FIELD SERVICE BULLETIN

FIELD SERVICE BULLETIN NO. 4
REVISED AUGUST 5, 1949

SUBJECT: INSPECTION OF NOSE GEAR RETRACTING DRAG LINK

EFFECTIVITY: NAVIONS, NAV-4-2 THROUGH 1150

FIGURE I

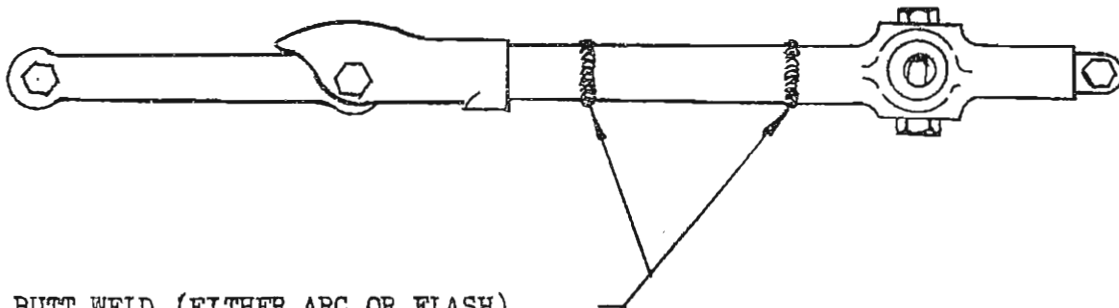
A few cases have been reported on earlier Navions where Nose Gear Retracting Drag Links, Part No. 145-34106 have failed in service. Despite the fact that a large number of these links have given many hours of service without trouble, it is considered necessary to reinforce all links having butt welds (either arc or flash) regardless of the position of the oil drain hole. Reinforced links will be furnished on an exchange basis by the Ryan Aeronautical Company and handled through authorized Ryan Navion Distributors or Dealers. Owners should contact their nearest Distributor or Dealer in advance to arrange for installation and make sure that reinforced links are available.

BUTT WELD (EITHER ARC OR FLASH)
IS UNSATISFACTORY AND BULLETIN
NO. 4 WILL APPLY

EITHER TYPE OF REINFORCEMENT IS
SATISFACTORY, BULLETIN NO. 4
WILL NOT APPLY

BOLT MUST ALLOW ABSOLUTE FREEDOM
OF KNUCKLE MOVEMENT

SHOULDER SHOULD TOUCH WHEN
IN PAST-CENTER POSITION

Install replacement links consisting of the following Part No. 145-34120 link assembly (less Part No. 145-34108 shaft) as follows:

1. Place airplane on jacks so landing gear can be operated.
2. Remove right hand engine cooling gill cover. Place a piece of dural or wood next to skin under lower nose gear bungee attachment. This is to prevent bungee from rotating too far and damaging indicating light switches.
3. Remove bolt attaching forward 145-34164 link from nose gear strut. Remove bolt connecting operating hydraulic cylinder to 145-34106 link. Remove bolt attaching 145-34106 link to bungee shaft.
4. Install reinforced link assembly by attaching link to bungee shaft with bolt previously removed. Install bolt, attaching link 145-34164 to nose gear strut. Connect hydraulic operating cylinder strut to link and safety.
5. Operate gear with hand pump at least three (3) operations, checking indicating lights and up-locks for proper functioning.

NOTE: It is important that the proper adjustments of the link installation be accomplished to eliminate faulty gear operation. For adjusting bungee, see Service Letter No. 39 or Navion Service Manual, page 48, figure 31, drawing number 145-33-342 revision C, reference items three (3) and four (4), which read as follows:
